Title: **TOP & POWER**

Project: NUCLEO-XXXXXXX			
Size: A4	Reference: MB1136	Revision: C.3	
Date: 9/26/2014		Sheet: 1 of 4	life.augmented

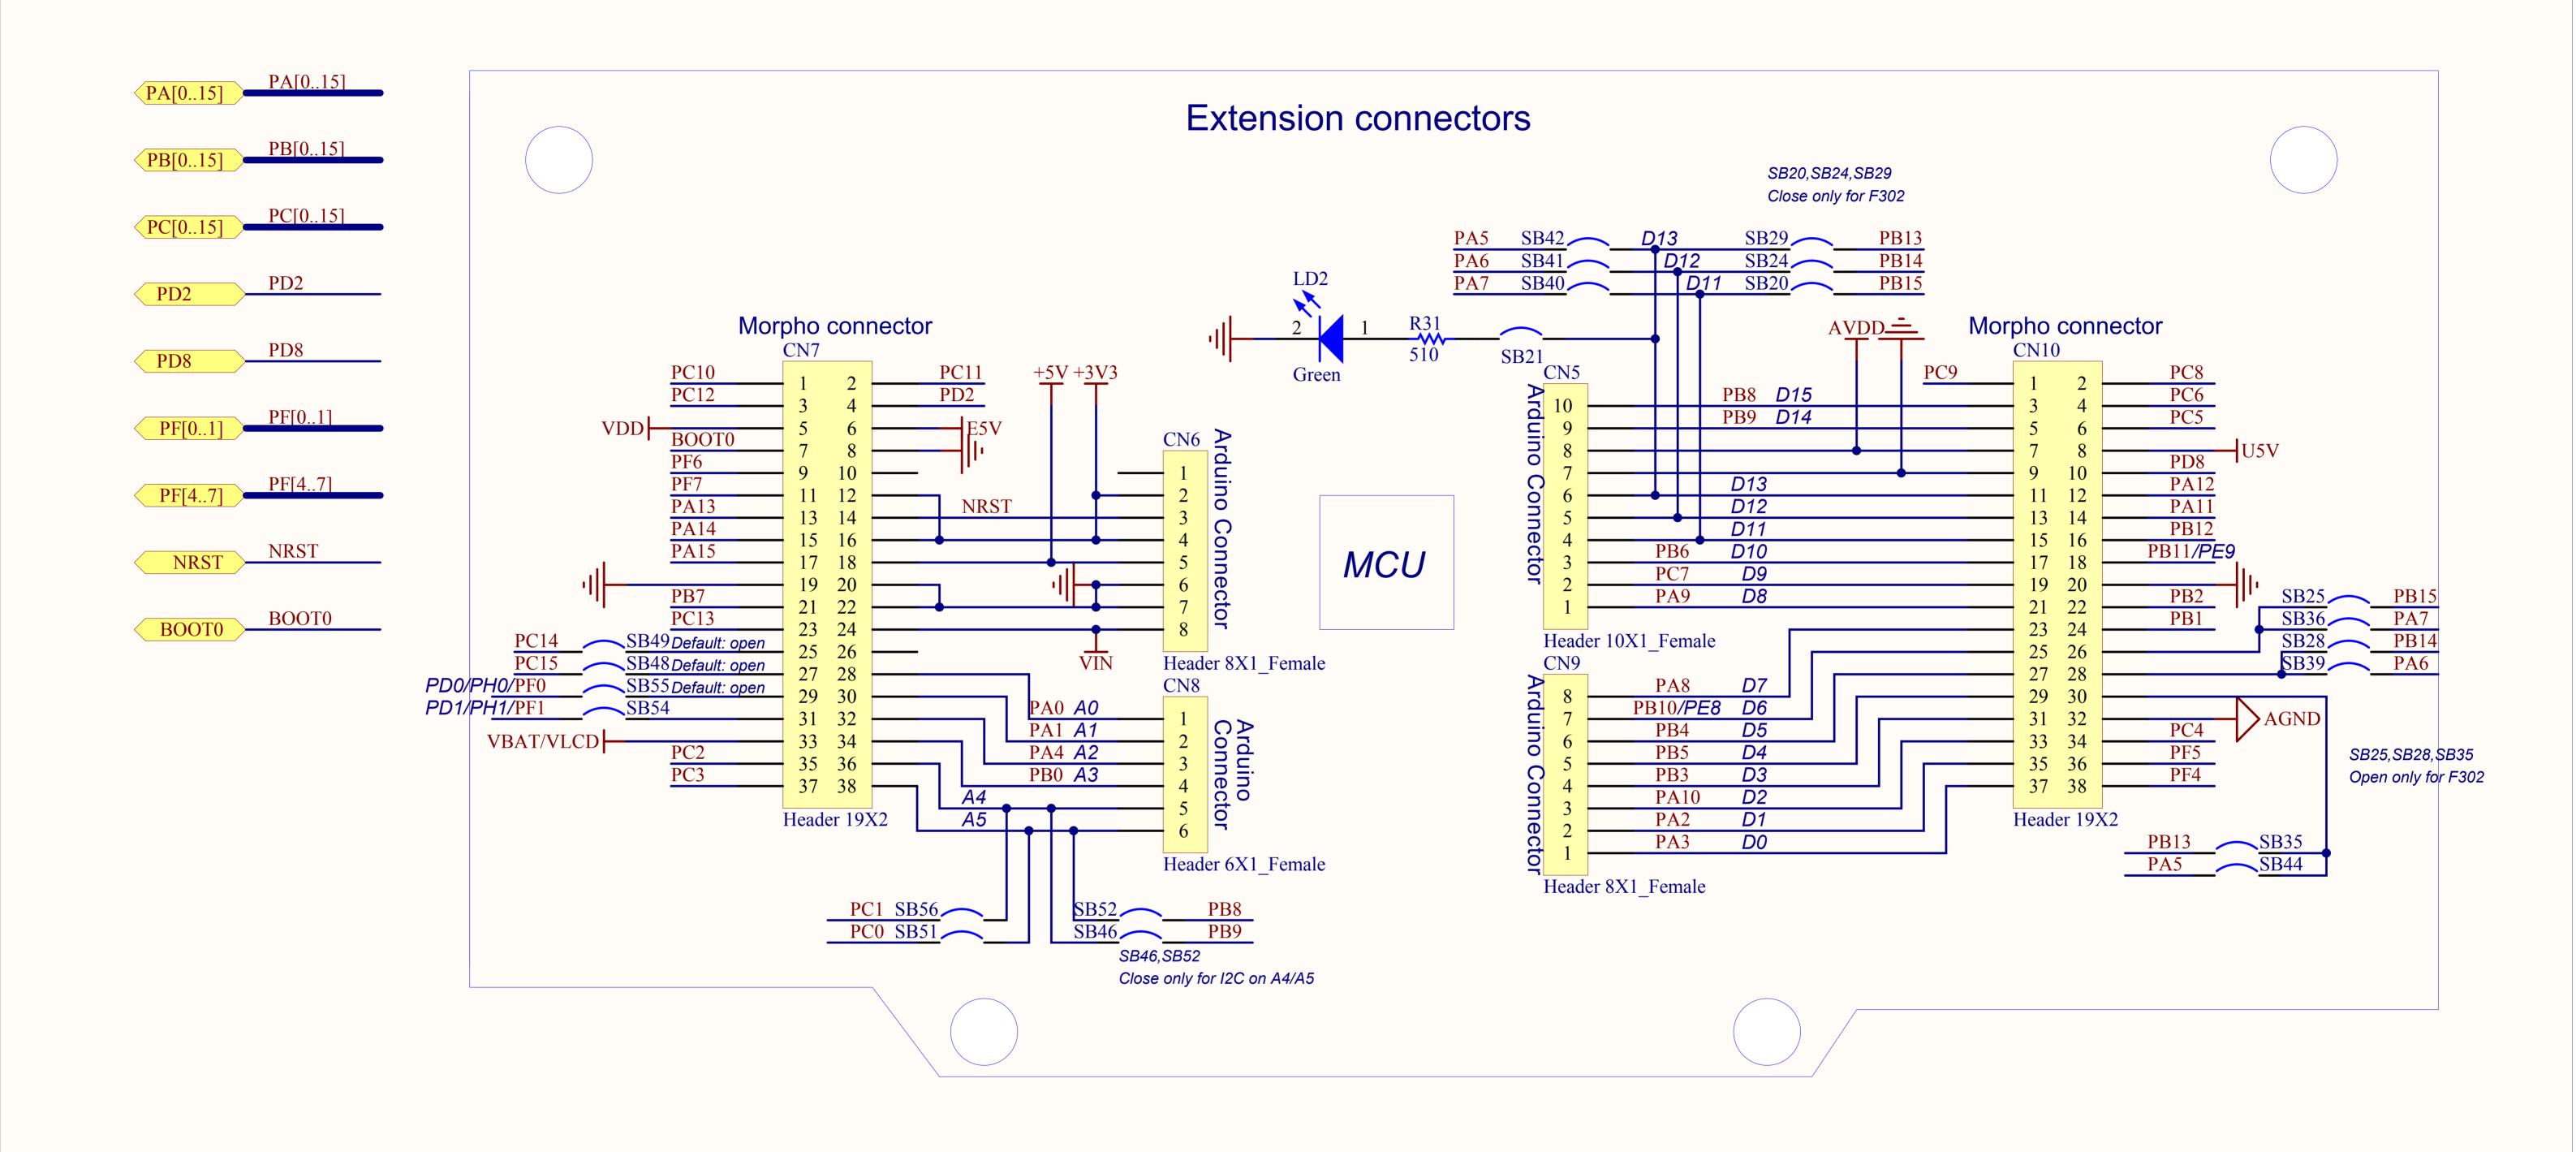
Note2: Remove [N/A] on R34, R36, C31, C32, X2 from C.1 to C.2

Note3: Add "default open" on SB48, SB49, SB55 from C.1 to C.2

Note4: Replace "default open" by "default closed" on SB16 & SB50 from C.1 to C.2

Note5: C31&C32 value changed from 10pF to 4.3pF to fit with new 32K crystal ABS25-32.768KHZ-6-T
